Well Name: FEDERAL AF	Well Location: T18S / R32E / SEC 8 / SESW /	County or Parish/State: LEA / NM
Well Number: 02	Type of Well: OIL WELL	Allottee or Tribe Name:
Lease Number: NMNM40448	Unit or CA Name:	Unit or CA Number:
US Well Number: 3002530606	Well Status: Producing Oil Well	Operator: MATADOR PRODUCTION COMPANY

Notice of Intent

Sundry ID: 2682231

Type of Submission: Notice of Intent	Type of Action: Plug and Abandonment
Date Sundry Submitted: 07/15/2022	Time Sundry Submitted: 09:35
Date proposed operation will begin: 07/22/2022

Sundry ID 2682231

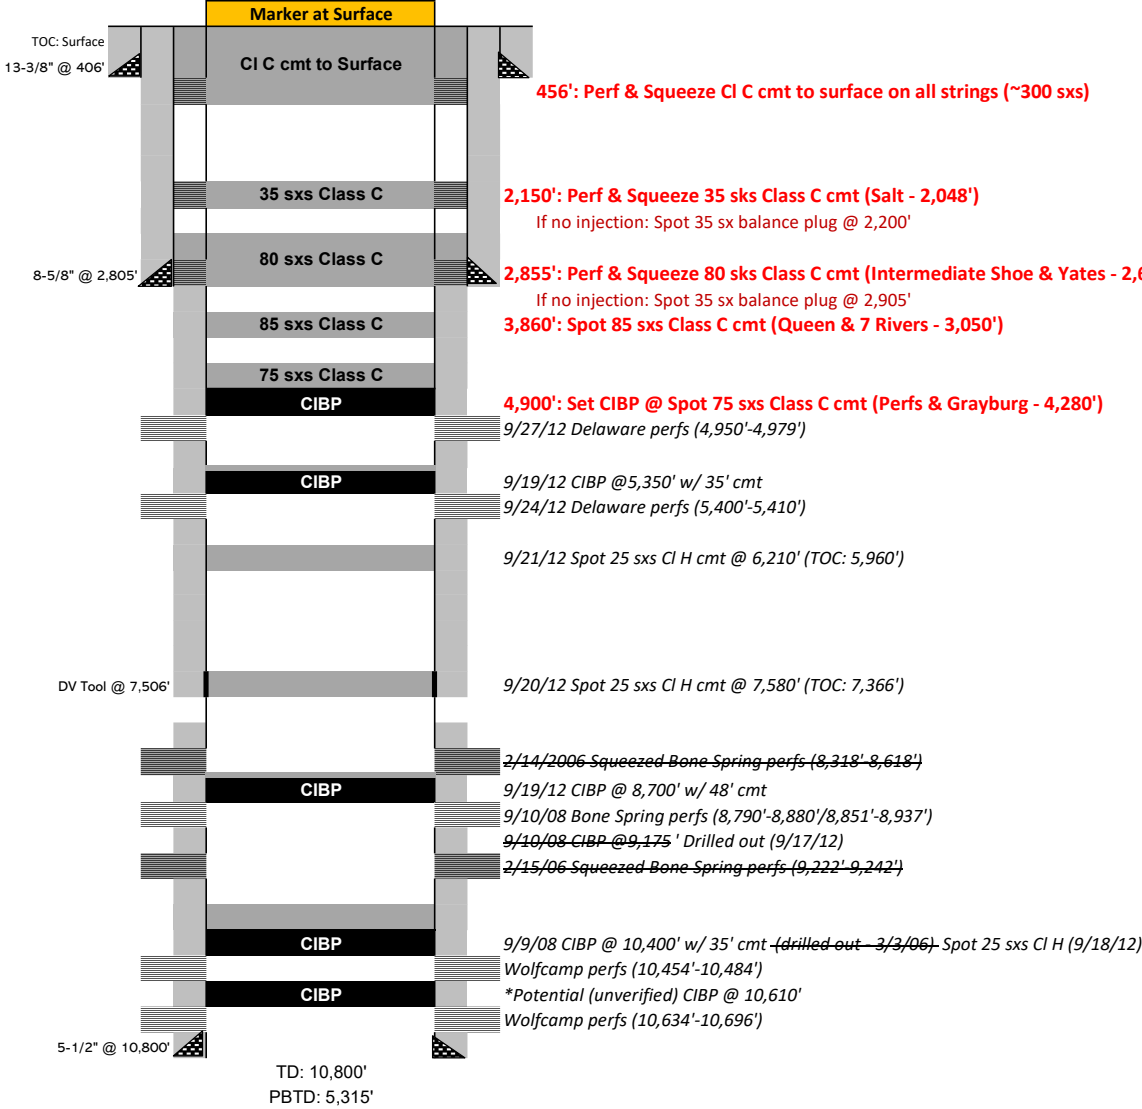
Plug Type	Top	Bottom	Length	Tag	Sacks	Notes
Surface Plug	0.00	456.00	456.00	Tag/Verify	300.00	Shoe + Surface. Perf and Sqz
Shoe Plug	351.94	456.00	104.06	Tag/Verify	300.00	Shoe + Surface. Perf and Sqz
Top of Salt @ 2098	2027.02	2148.00	120.98	Tag/Verify	35.00	
Shoe Plug	2726.95	2855.00	128.05	Tag/Verify	80.00	Shoe+BOS+Yates
				If solid base no need to Tag (CIBP present and/or Mechanic al Integrity Test), If Perf & Sqz then Tag, Leak Test all CIBP if no Open Perforatio ns		
Yates @ 2665	2588.35	2715.00	126.65		80.00	Shoe+BOS+Yates
Base of Salt @ 2665	2588.35	2715.00	126.65	Tag/Verify	80.00	Shoe+BOS+Yates
				If solid base no need to Tag (CIBP present and/or Mechanic al Integrity Test), If Perf & Sqz then Tag, Leak Test all CIBP if no Open Perforatio ns		
Delaware @ 4945	4845.55	4995.00	149.45		75.00	Covered by CIBP plug

If solid base no need to Tag (CIBP present and/or Mechanic al Integrity Test), If Perf & Sqz then Tag, Leak Test all CIBP if no Open Perforatio ns		
CIBP Plug	4865.00	4900.00	35.00		75.00	Pressure test 500psi, 30 mins

**No more than 2000' is to be allowed between plugs in open hole, and no more than 3000' between plugs in cased hole.**

**R111P: Solid plug in all annuli - 50' from bottom of salt to surface.**

**Onshore Order 2.III.G Drilling Abandonment Requirements: "All formations bearing usable-quality water, oil, gas, or geothermal resources, and/or a prospectively valuable deposit of minerals shall be protected.**
